Work Order ID 98180

Item Name: Crosstube Mid Fwd. Blue

DESIGN		DART AEROSPACE LTD	
DRAWN		HAWKESBURY, ONTARIO, CANADA	
CHECKED		DRAWING NO.	REV. A
MFG. APPR.		D206-667-147	SHEET 3 OF 4
APPROVED		TITLE	SCALE
DE APPR.		CROSSTUBE ASS'Y (206L MID FWD)	NTS
DATE	10.12.23	COPYRIGHT © 2010 BY DART AEROSPACE LTD THIS DOCUMENT IS PRIVATE AND CONFIDENTIAL AND IS SUPPLIED ON THE EXPRESS CONDITION THAT IT IS NOT TO BE USED FOR ANY PURPOSES OR COPIED OR REPRODUCED IN ANY FORM WITHOUT THE WRITTEN PERMISSION FROM DART AEROSPACE LTD.

DRAWING NO. D206-667-147	TITLE CROSSTUBE ASS'Y (206L MID FWD)	REV. A	DART AEROSPACE LTD ENGINEERING ORDER		D.E.O. NO. D206-667-147-A-1	SHEET NO. SHEET 1 OF 1	SCALE NTS
DRAWN <i>q</i>	CHECKED <i>ASS</i>	MFG. APPR. <i>SS</i>	APPROVED <i>MD</i>		DE APPR. <i>MD</i>		
DATE 11.07.15	DATE 11.07.20	DATE 11.07.21	DATE 11/07/21		DATE 11.07.21

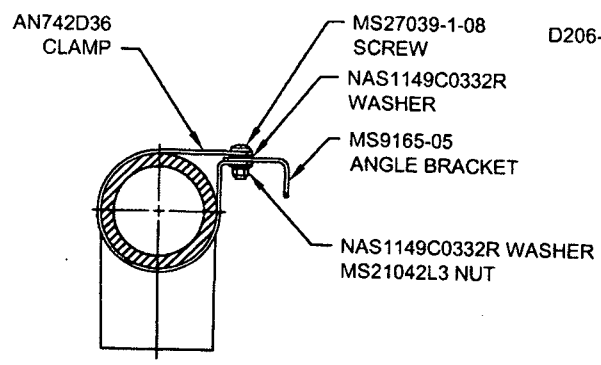
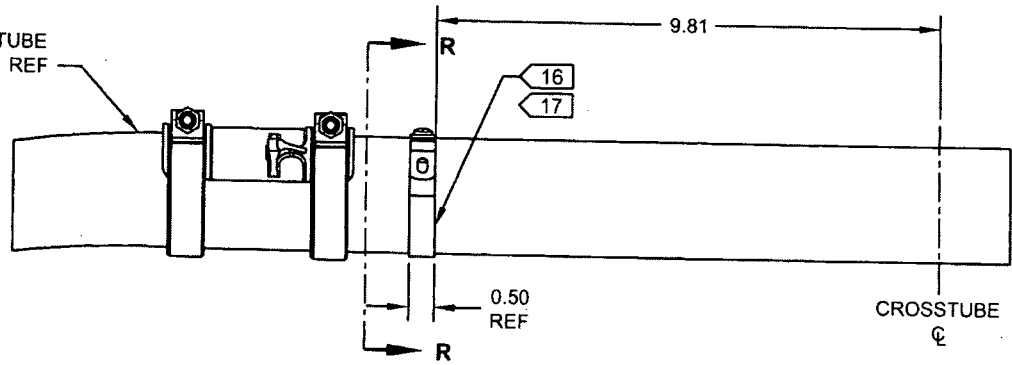
ADD ELECTRICAL GROUNDING STRAP

- 16) MASK AREA UNDER CLAMP PRIOR TO PAINTING
- 17) SEAL EDGES WHERE AN742D36 CLAMP MEETS WITH THE CROSSTUBE USING SIKAFLEX-241/-291 OR MIL-S-8802 CLASS B2 OR PROSEAL 890 SEALANT
- 18) PERFORM RESISTANCE CHECK TO ENSURE MAX RESISTANCE IS 10 MILLIOHMS
